SUBMISSION FORM 13

SUB-2016-84 & LUC-2016-430 Site Address: Applicant: Janet and Andrea Warburton Description of Proposal: The proposal is to subdivide the subject site at 111A Cliffs Road, Dunedin, into two new lots. I/We wish to lodge a submission on the above resource consent application: Your Full Name: 2 0 CCT 2016 Address for Service (Postal Address): Business Information Den HOLEH Telephone: Post Code: (REST Facsimile: Email Address: I: Support/Neutral Oppose his Application If others make a similar submission, I will consider presenting a joint case with them at a hearing. Not wish to be heard in support of this submission at a hearing (Delete the above statement if you would not consider presenting a joint case at a hearing) The specific parts of the application that this submission relates to are: Please use the back of this form or attach other pages as required My submission is [include the reasons for your views]: MATTERS INTERNATIONA The decision I wish the Council to make is [give precise details, including the parts of the application you wish to have amended and the general nature of any conditions sought]: Plebis Signature of submitter: (or person puthwriged to s

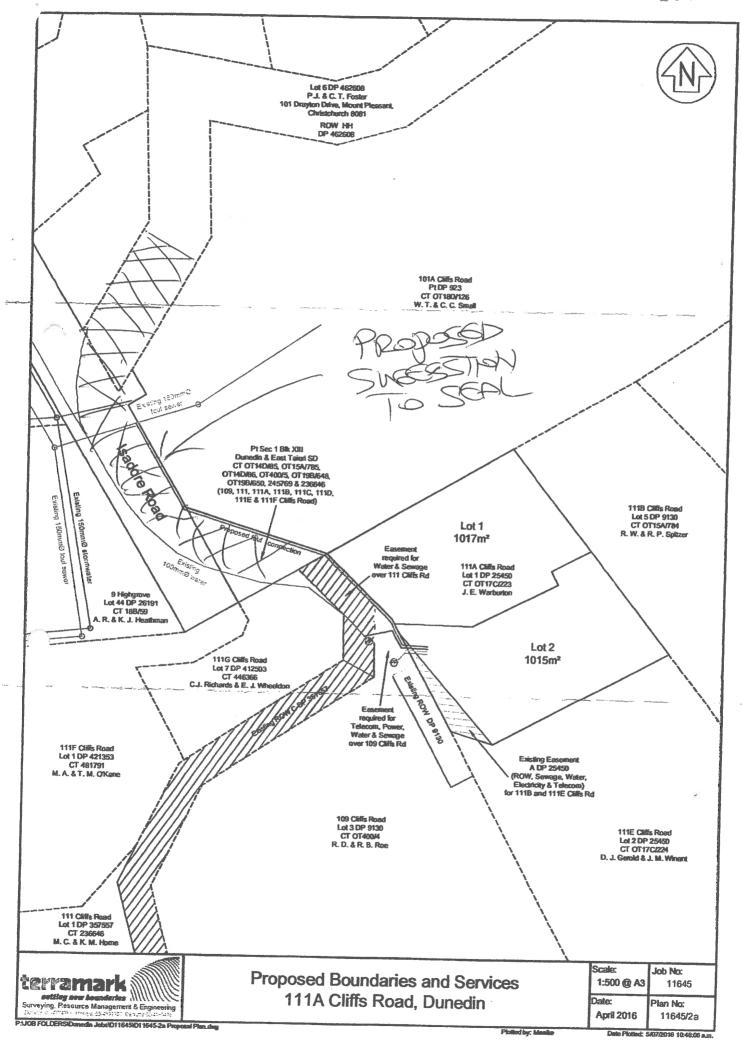
It is our opinion that similar consideration be given to mitigate the negative effects and loss of amenity at the upper end of the access. Starting from the corner preceding Isadore paper road for some 60 -70 metres or through to the proposed subdivision site. A speed bump would also be a method of mitigating some effects. See attached diagram.
